CONNECTION ASSESSMENT & APPROVAL PROCESS

*Project: Installation of series reactors on the SC1 & SC2 13.8kV
Capacitor Banks at Leaside TS*

CAA ID No. 2003-EX126

LEASIDE TS - Install Series Reactors on the SC1 & SC2 Capacitor Banks

DIAGRAM 2

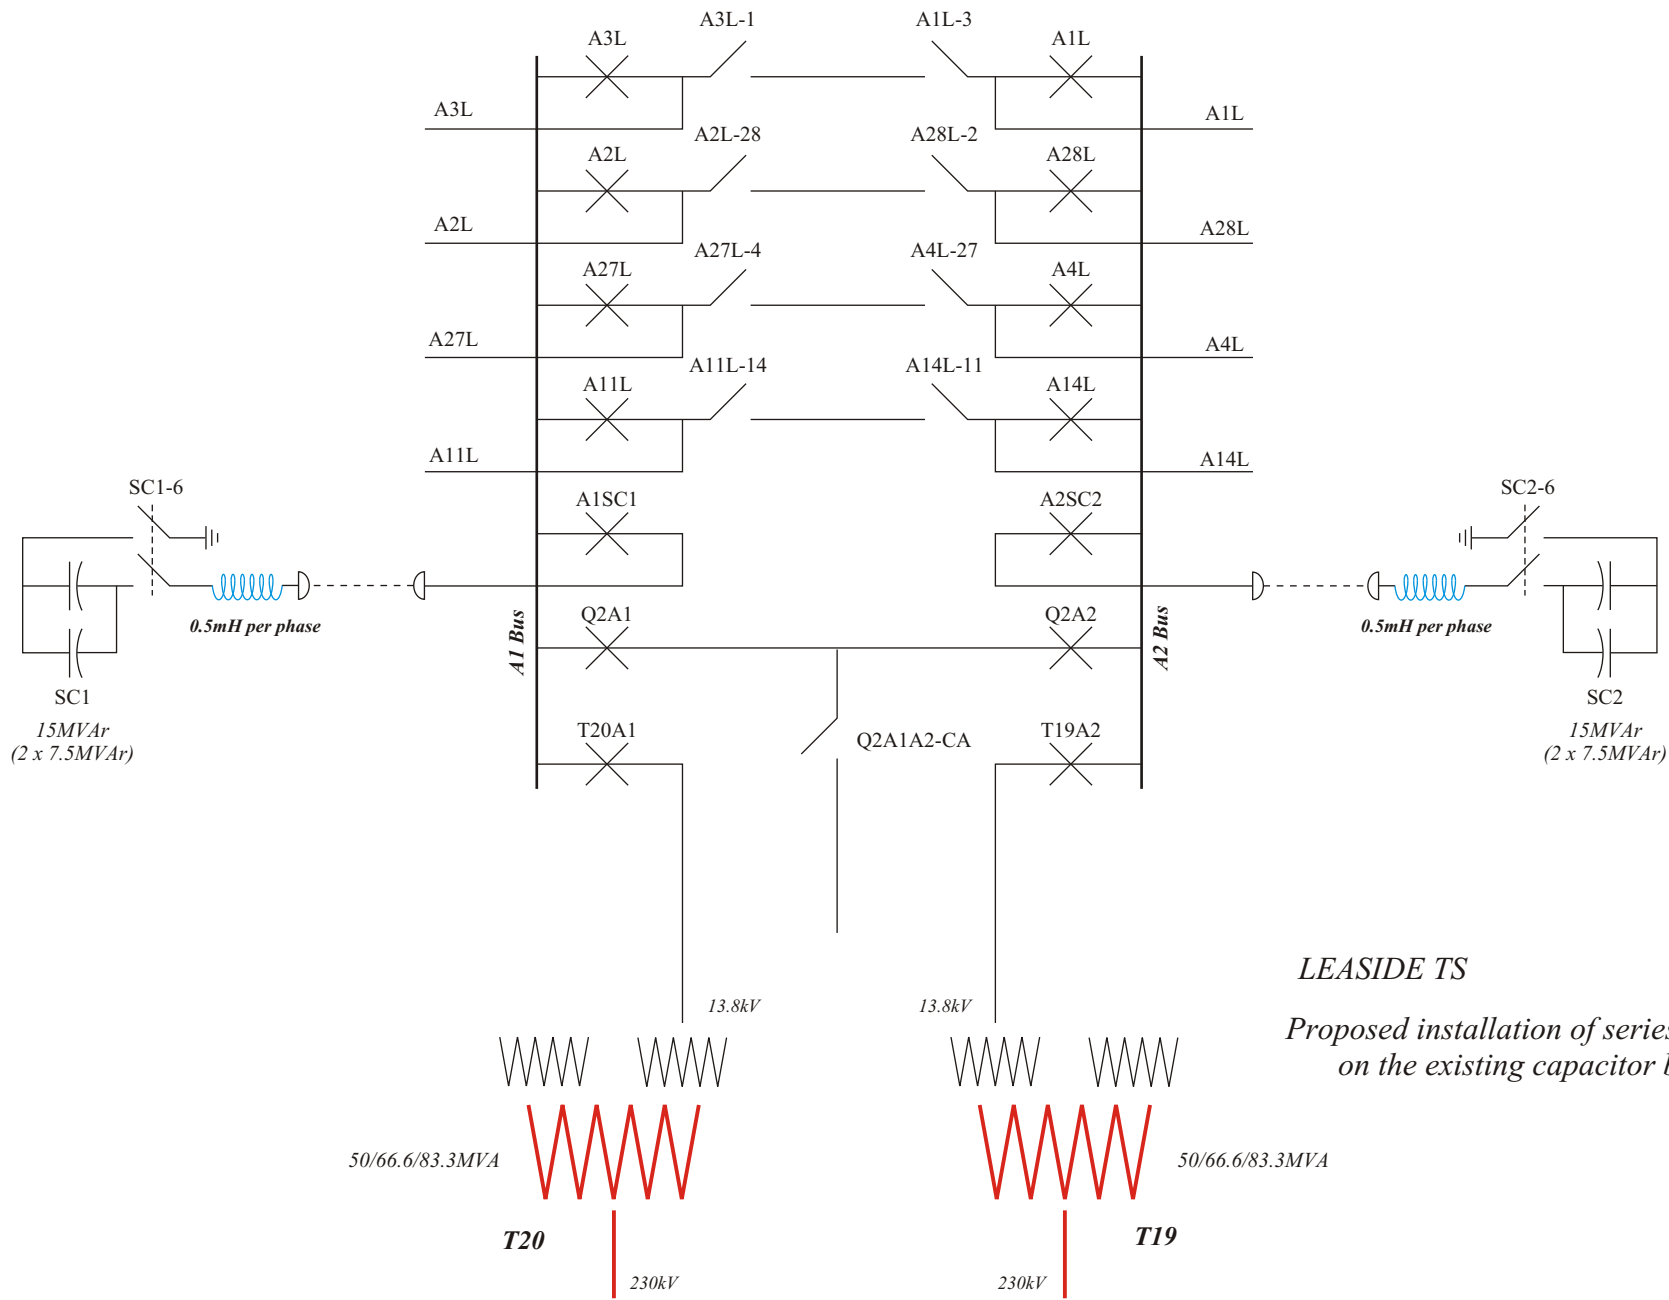
The location of the two sets of series reactors that it is proposed to install is shown in Diagram 2.

The installation of these series reactors and the subsequent reduction in the in-rush and out-rush currents would reduce the duty imposed on each of the capacitor breakers and limit the possibility that they could malfunction.

This work is therefore considered to be beneficial and will have no negative impact on the IMO-controlled grid.
